# Access Compliance Report

## Public Rights-of-Way

### (Curb Ramps)

Intersection ID: 2899	Main Street: RIDGE_RD	Cross Street: WAVERLY_LYNN_LN	Location: NW
ADA ID: 2EDF48019586	Ramp Type: Perp	Initial Pass/Fail: Fail	Overall Compliance: No
		Severity Score: 25

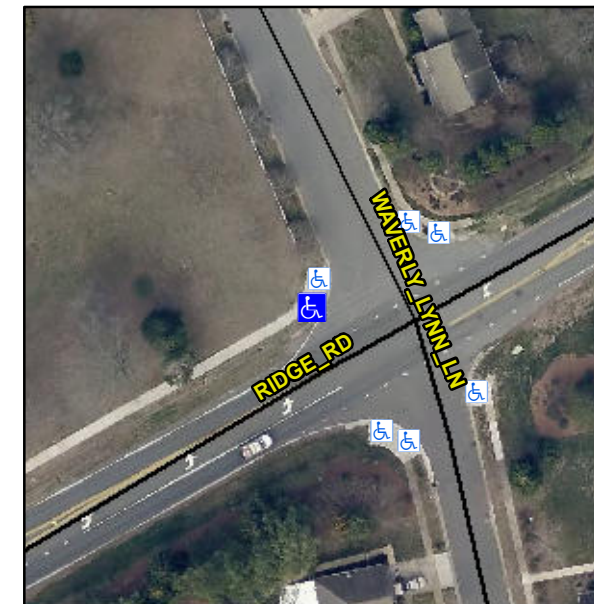
**R304.5.3**

Compliance	Description	Data	Compliance	Description	Data
N/A	Ramp Length (in)	63.0	Yes	Ramp Slope (%)	5.6
Yes	Ramp Width (in)	48.0	No	Ramp XSlope (%)	8.3
N/A	Flare Type LT	N/A	N/A	Flare Type RT	N/A
N/A	Flare Slope LT (%)	N/A	N/A	Flare Slope RT (%)	N/A
N/A	Flare Traversable LT?	N/A	N/A	Flare Traversable RT?	N/A
N/A	Landing Length (in)	N/A	N/A	DWS Provided?	N/A
N/A	Landing Width (in)	N/A	N/A	DWS Contrast?	N/A
N/A	Landing Slope (%)	N/A	N/A	DWS Length (in)	N/A
N/A	Landing X Slope (%)	N/A	N/A	DWS Full Width?	N/A
N/A	Landing Curb? (Y/N)	N/A	N/A	DWS Offset (in)	N/A
N/A	Shared Landing?	N/A			
N/A	Gutter Ponding?	N/A	N/A	Gutter Slope (%)	N/A
N/A	Gutter Lip Ht (in)	N/A	N/A	Gutter X Slope (%)	N/A
N/A	Painted X Walk1?	No	N/A	Painted X Walk2?	N/A
	X Walk 1 Direction	To S		X Walk 2 Direction	N/A
N/A	X Walk 1 Width (in)	N/A	N/A	X Walk 2 Width (in)	N/A
	X Walk 1 Slope (%)	7.1		X Walk 2 Slope (%)	N/A
	X Walk 1 X Slope (%)	3.4		X Walk 2 X Slope (%)	N/A

**Remove & Replace Entire Ramp.**
